Responses to Anonymous Referee #1 (Page 1)

Fig. 1: Nested WRF configuration for the original manuscript (left) and the revised manuscript (right). The colored lines in the right panel show the GFS model analysis storm tracks for each of the seven cases.

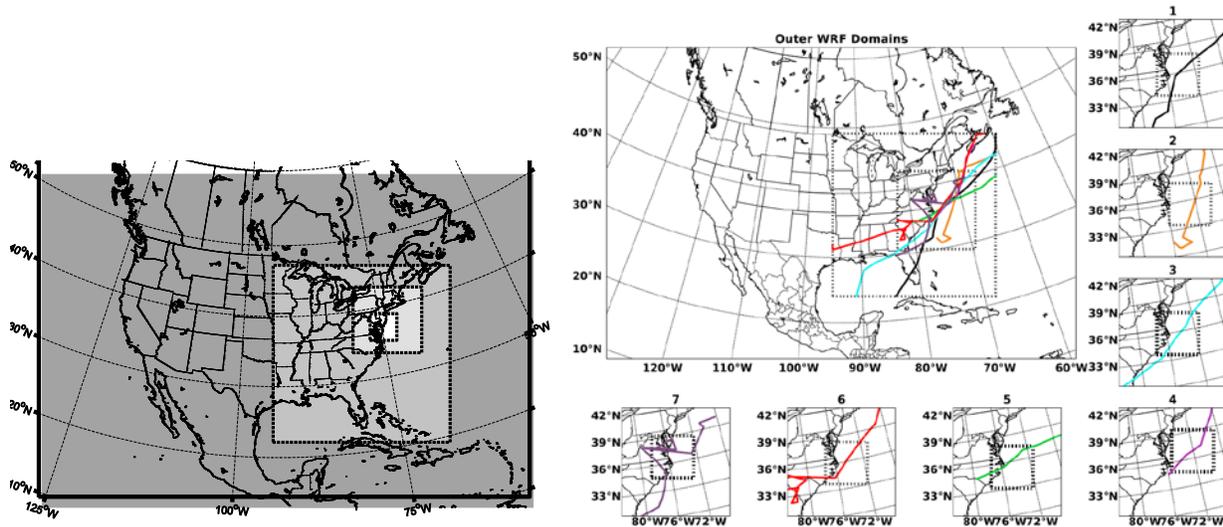
4) *“There are also aspects of the model set-up that I would criticize. It seems that the central 1.67 km domain is at the same position for all storms, and this means that some storms pass through it while other would miss it and only be resolved in the 5 km domain”*

The WRF model domain positions were fixed for all nor'easter cases. This led to a situation where WRF-simulated nor'easters in cases 1 and 4 either missed or never fully entered the 1.667 km model grid (Domain 4) as the reviewer hypothesized. We have since increased the sizes of the 5 km and 1.167 km (Domains 3 and 4, respectively) by 50%, shifted domain 3 southward, and tailored the location of domain 4 for all seven nor'easter events. To physically demonstrate these changes, Figure 1 shows our original and new WRF model configuration. All 35 model simulations were re-run and reanalyzed accordingly. As can be seen below, each model analysis track moves through the center of each respective domain 4.

Fig. 2: 850-hPa wind speed (fills, m s⁻¹) and sea-level pressure (contours, hPa) on 13 March 2010 at 18 UTC (Case 7).

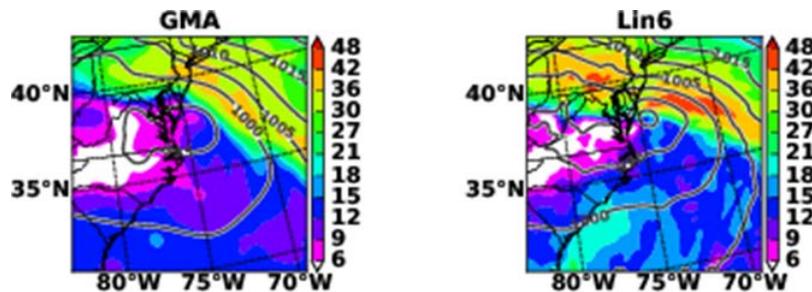
13. line 334. Regarding the low-level jet which case is being referred to? Can it really be inferred from the v component of the energy norm that this jet is the cause? This looks highly speculative.

We agree with the reviewer’s viewpoint that the energy norm by itself could be considered speculative for Case 7. Our decision to not include a figure of 850-hPa winds (See Figure 2 below) in the original manuscript was made on the assumption that presence of the cyclone center, the small size of the model domain, and a bump in the u and v energy norm components at 850-hPa would be sufficient circumstantial evidence to support our claim without the need for an additional figure. In the revised manuscript, the energy norm section has been removed from the paper.
